LIMERICK GENERATING STATION  
UNITS 1 and 2

TECHNICAL SPECIFICATIONS CHANGE REQUEST

No. 91-04-0

"Revision of Snubber Functional Testing  
Surveillance Requirements"

Figure 4.7.4-1  
SAMPLE PLAN 2) FOR SNUBBER FUNCTIONAL TEST

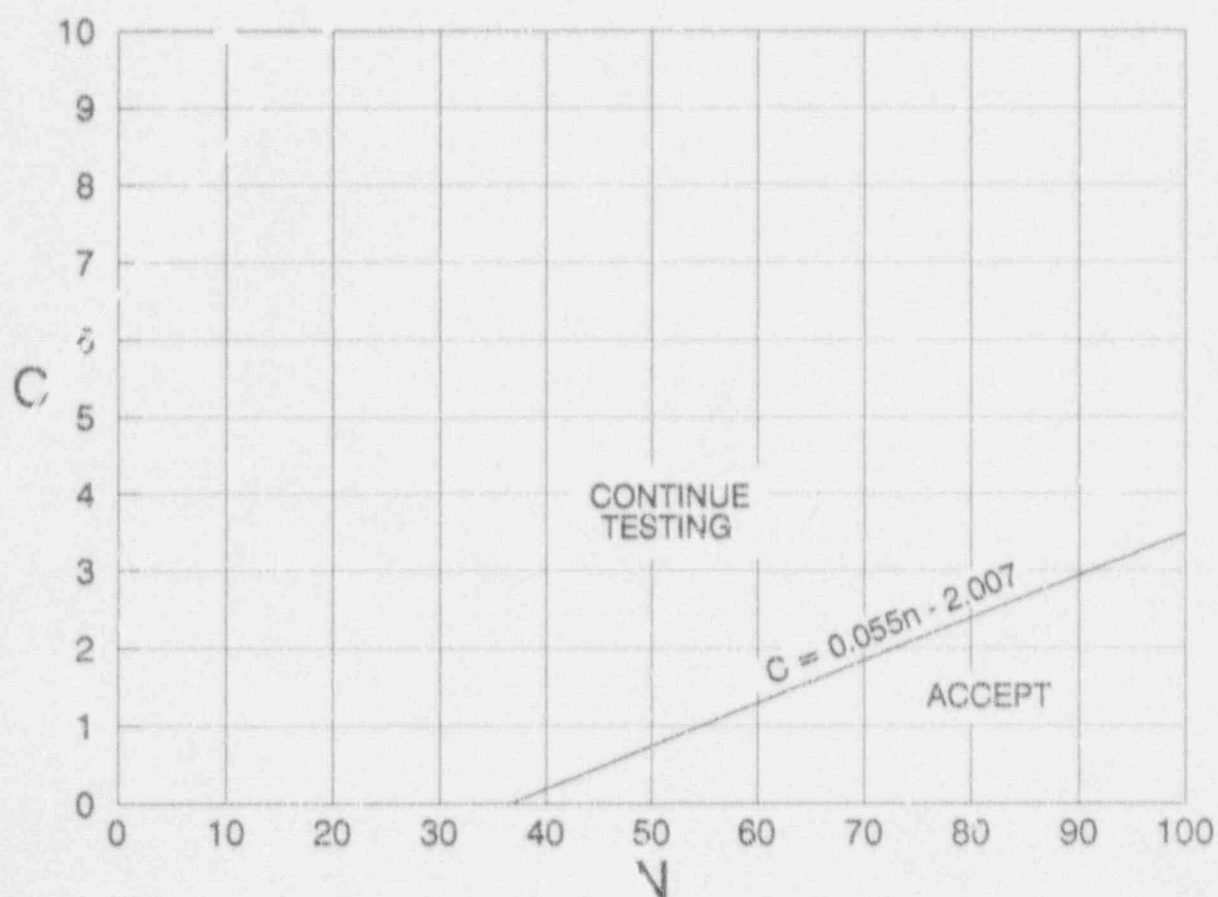
The 37 plan (i.e., SR 4.7.4.e.2) uses TS Figure 4.7.4-1 to determine the need to continue testing. The "accept" line of this figure is based on the equation  $C = 0.055N - 2.007$  where 'N' is the number of snubbers of a type that is tested, and 'C' is the total number of snubbers of a type not meeting the TS acceptance requirements. This equation was developed using "Wald's Sequential Probability Ratio Plan," as described in "Quality Control and Industrial Statistics," by Acheson J. Duncan. The equation used in ASME OM4 has the same basis except it has been rearranged for clarity. The revised 10% plan exactly matches the 37 plan at a population of 370 snubbers which gives the 10% plan statistical significance in its revised form. The original form of the 10% plan was not based on statistics so adaptation of the revised form will allow this plan to be consistent with current industry practices.

Removal of the "reject" line from the 37 plan is justified for the following reason. The FMG eliminates the need to test all snubbers of a certain type and allows normal testing to continue with added focus on the specific mechanisms causing failures. Also, removal of the "reject" line does not preclude the possibility that all snubbers of a given type will be tested as an FMG, if required by the test results.

- b. Removal of the "reject" line from the 37 plan, which results in an expanded "continue testing" region, will not reduce the effectiveness of the plan to detect failed or degraded snubbers. Snubber testing must still continue until the test results fall within the "accept" region or until all snubbers are tested, thus providing the same statistical confidence in the completed test.

- 2) A representative sample of 37 snubbers of a snubber type shall be functionally tested in accordance with Figure 4.7.4-1. "C" is the total number of snubbers of that type found not meeting the acceptance requirements of Specification 4.7.4f. The cumulative number of snubbers of the type tested is denoted by "N". If at any time the point plotted falls in the "Accept" region, testing of snubbers of that type may be terminated. When the point plotted lies in the "Continue Testing" region, additional snubbers of that type shall be tested until the point falls in the "Accept" region, or all the snubbers of that type have been tested.
